**TOWN OF MOUNTAIN VILLAGE
REGULAR DESIGN REVIEW BOARD MEETING AGENDA
TO BE HELD IN PERSON
THURSDAY OCTOBER 7, 2021 10:00 AM
MOUNTAIN VILLAGE TOWN HALL
455 MOUNTAIN VILLAGE BLVD, MOUNTAIN VILLAGE, COLORADO
MOUNTAIN VILLAGE TOWN HALL**

TO: Mountain Village Design Review Board
FROM: Amy Ward, Planner
FOR: Design Review Board Public Hearing; October 7, 2021
DATE: September 27, 2021
RE: Staff Memo – Final Architecture Review (FAR) Lot 810A, 118 Arizona Drive

SITE PLAN

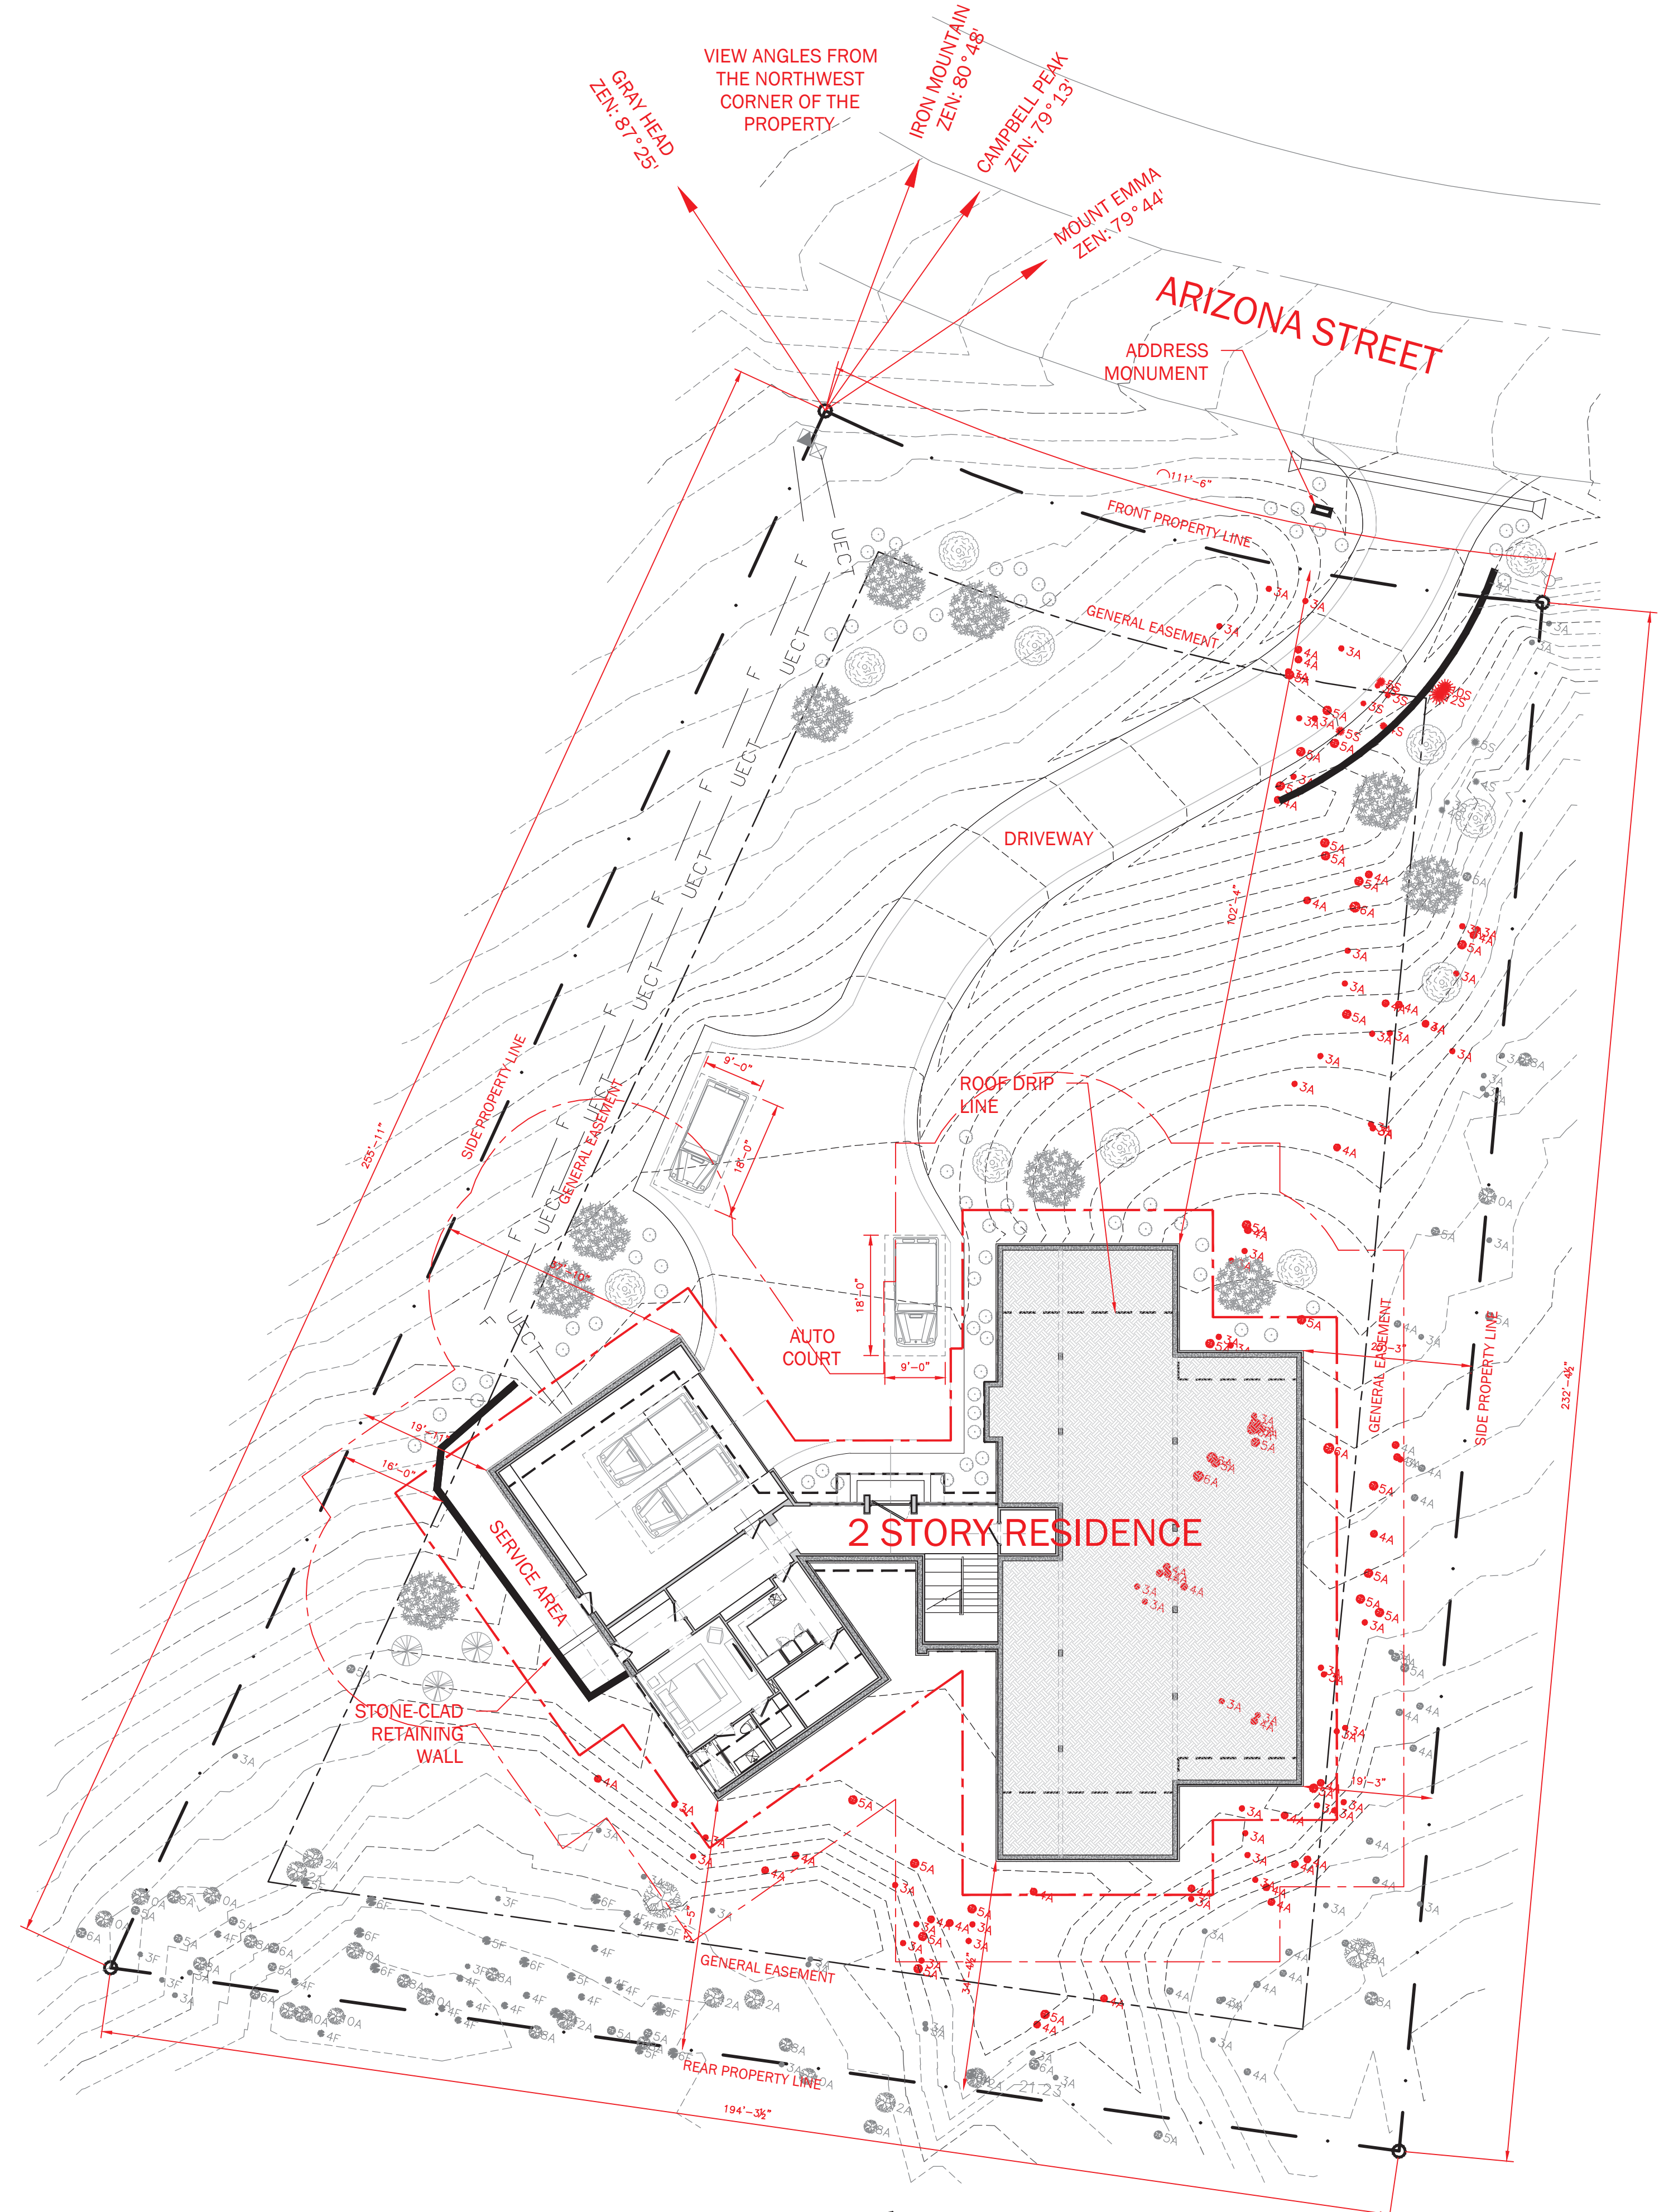
Lot 810A is burdened by a sixteen (16) foot General Easement (GE) which surrounds its perimeter. The CDC provides that the GE and other setbacks be maintained in a natural, undisturbed state to provide buffering to surrounding land uses. The CDC does provide for some development activity within the GE and setbacks such as Ski Access, Natural Landscaping, Utilities, Address Monuments, and Fire Mitigation. All encroachments not listed above will require encroachment agreements between the property owner and the Town.

- *Driveway: The Driveway as shown currently takes access from Arizona Drive and crosses the General Easement to the homesite. There is also a retaining wall associated with the driveway at the NE corner of the GE.*
- *Utilities: Given Lot 810A's location and the location of the existing utilities, the GE will need to be crossed on the North GE, accessing utilities within Arizona Drive.*
- *Landscaping: There is some proposed new planting in the northern and eastern GE as well as the address monument in the GE to the west of the driveway.*

LANDSCAPE & FIRE MITIGATION PLAN

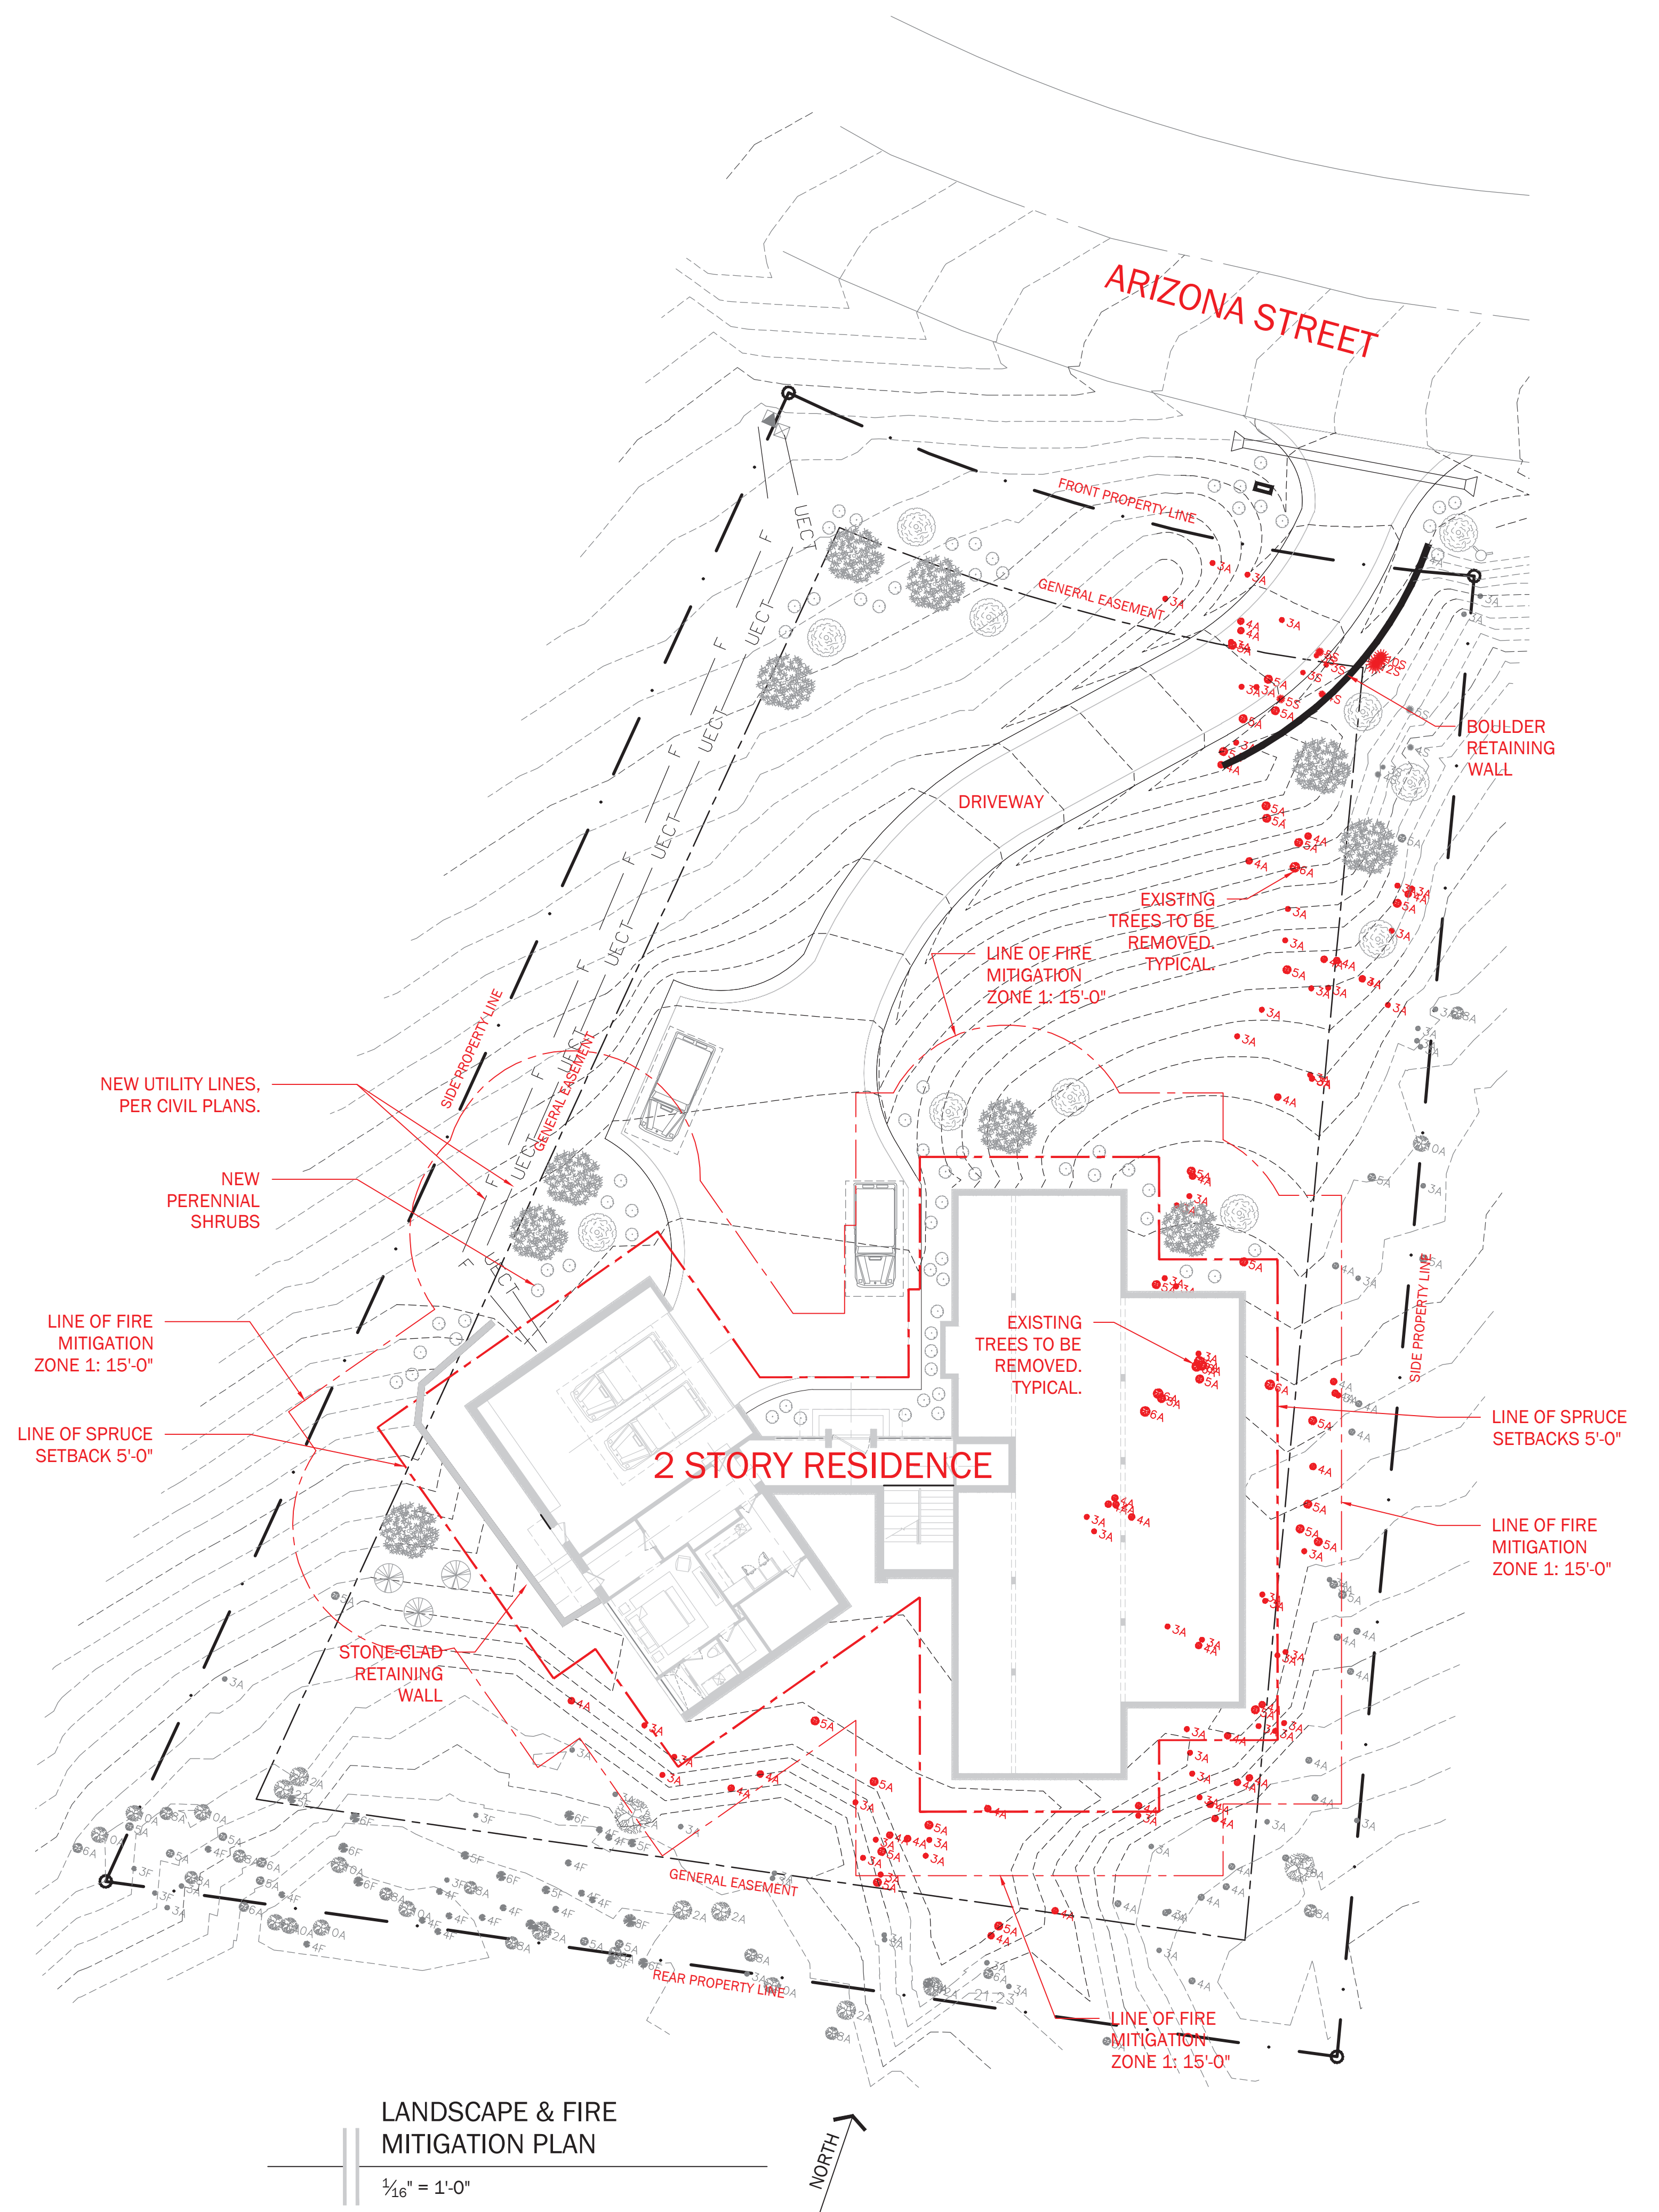
Staff: The applicant updated the plan to move all spruce at least 5' from edge of home and added additional plantings to the east of the driveway. Criteria met.
